SUBDIVISION REVIEW SHEET**CASE NO.:** C8J-2019-0141.1A**P.C. DATE:** June 8, 2021**SUBDIVISION NAME:** Skyline 2-D Phase 1 Final Plat**AREA:** 22.66 acres**LOT(S):** 101**OWNER/APPLICANT:** Carma Easton, LLC
(AJ Zorn)**AGENT:** Carlson, Brigrance, and Doering, Inc
(Brett Pasquarella)**ADDRESS OF SUBDIVISION:** 8321 Thaxton Road**GRIDS:** J/K12**COUNTY:** Travis**WATERSHED:** Marble/Cottonmouth Creek**JURISDICTION:** Limited Purpose**EXISTING ZONING:** Planned Unit Development (PUD)**MUD PLAN:** Pilot Knob MUD**DISTRICT:** 2**PROPOSED LAND USE:** Residential- Single Family; park/greenbelt/access/utility/drainage easement lots, and public ROW**VARIANCES:** None**SIDEWALKS:** Sidewalks will be provided along all internal streets and the boundary street.

**CITY OF AUSTIN – TRAVIS COUNTY – SINGLE SUBDIVISION OFFICE
SUBDIVISION APPLICATION – MASTER COMMENT REPORT**

PROJECT NAME: Skyline 2D Phase 1 Final Plat
LOCATION: 8321 THAXTON RD

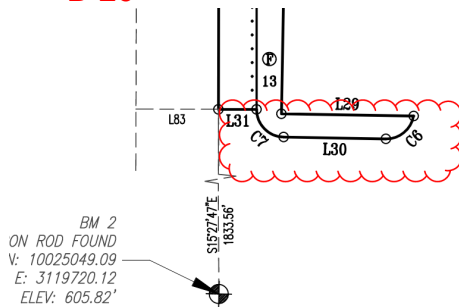
TR2. Please show sidewalk along L30, shown below (30-1-113):
